Proposed TS Pages

9209110157 920204
PFR HDOCK OSPDR
0500221

FIGURE 4.1-1. GRAPHICAL AID FOR THE SELECTION OF AN ADEQUATE INTERVAL BETWEEN TESTS.

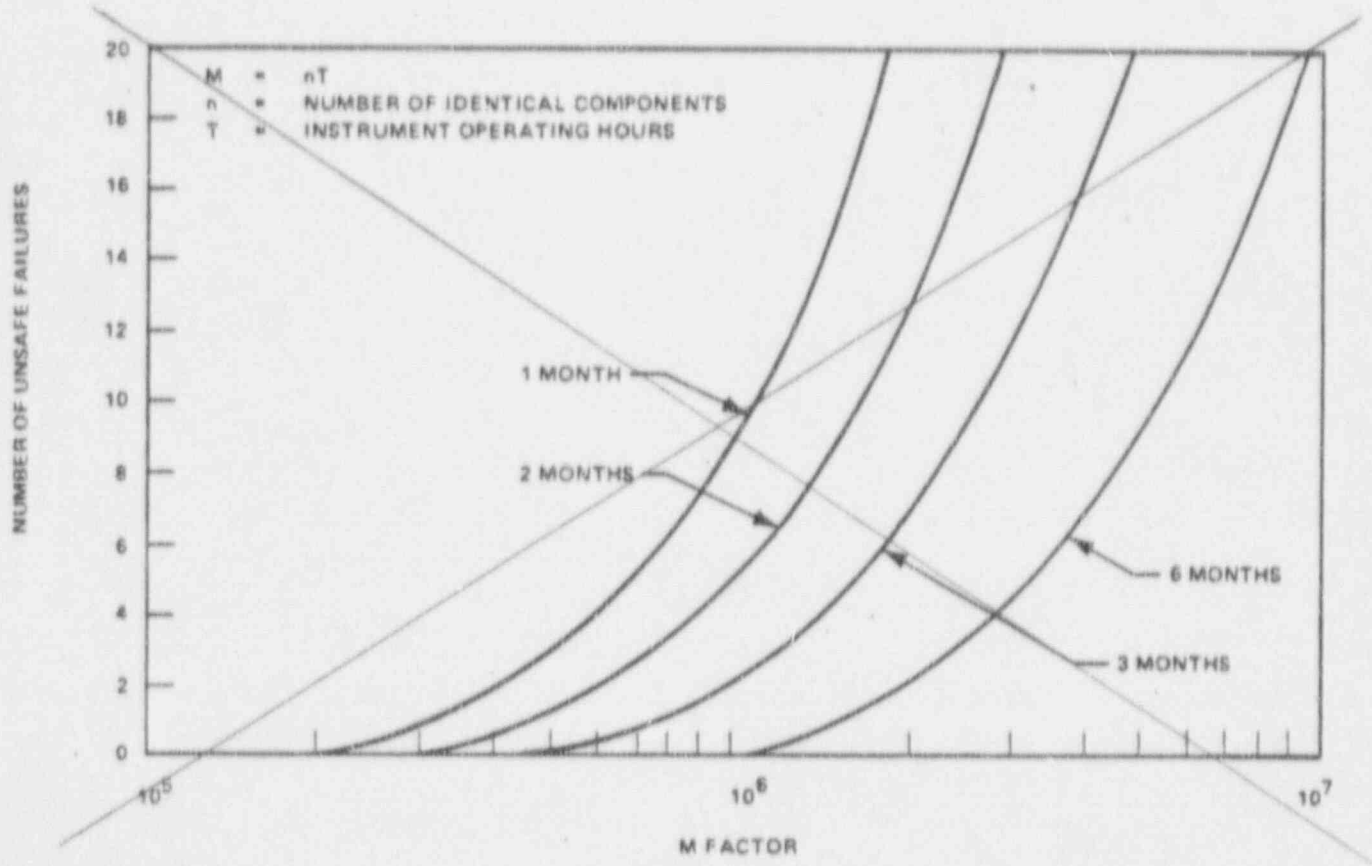
(Delete)

Figure 4.1-1 Deleted

FIGURE 4.2-1. SYSTEM UNAVAILABILITY

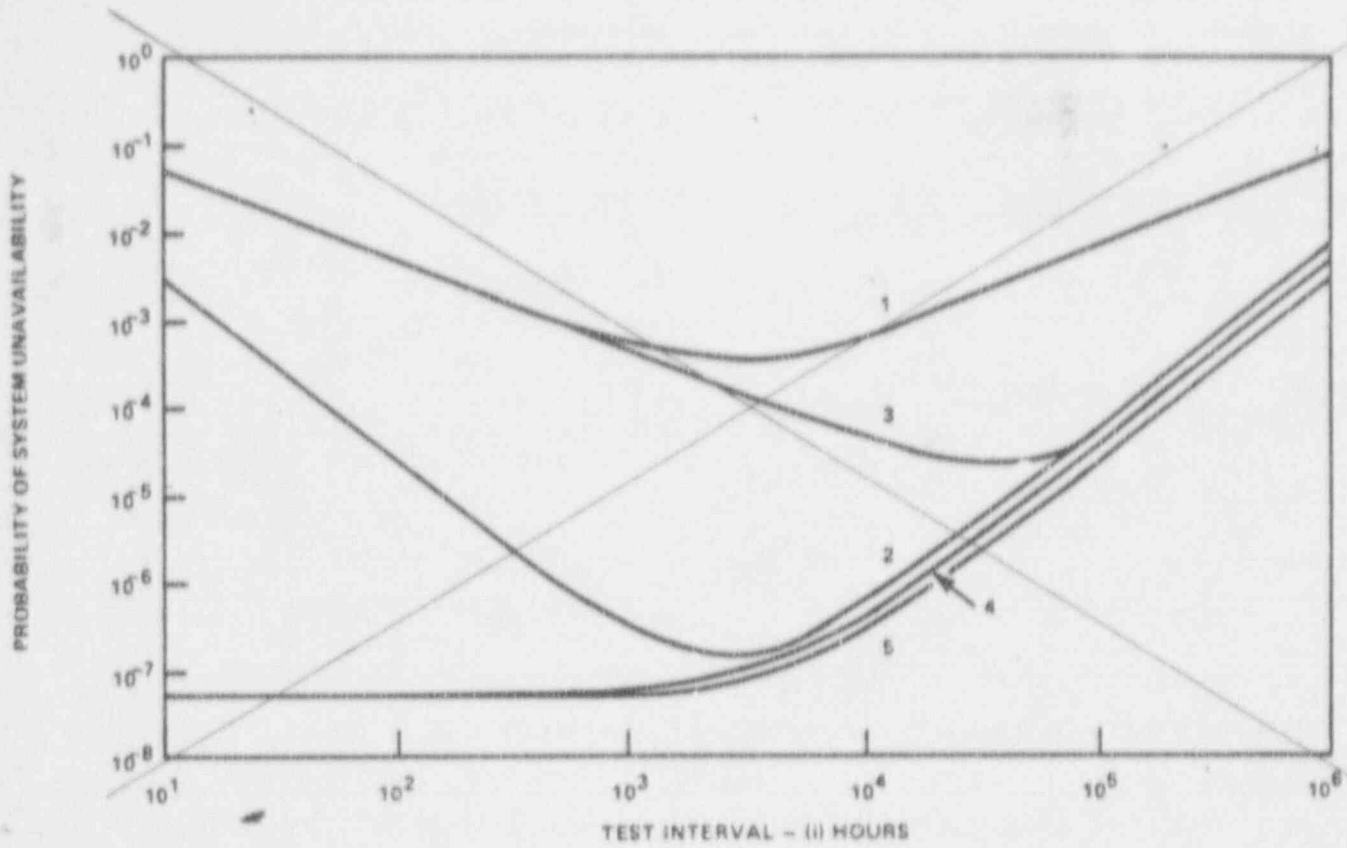
(Delete)

FIGURE 4.2-1 Deleted
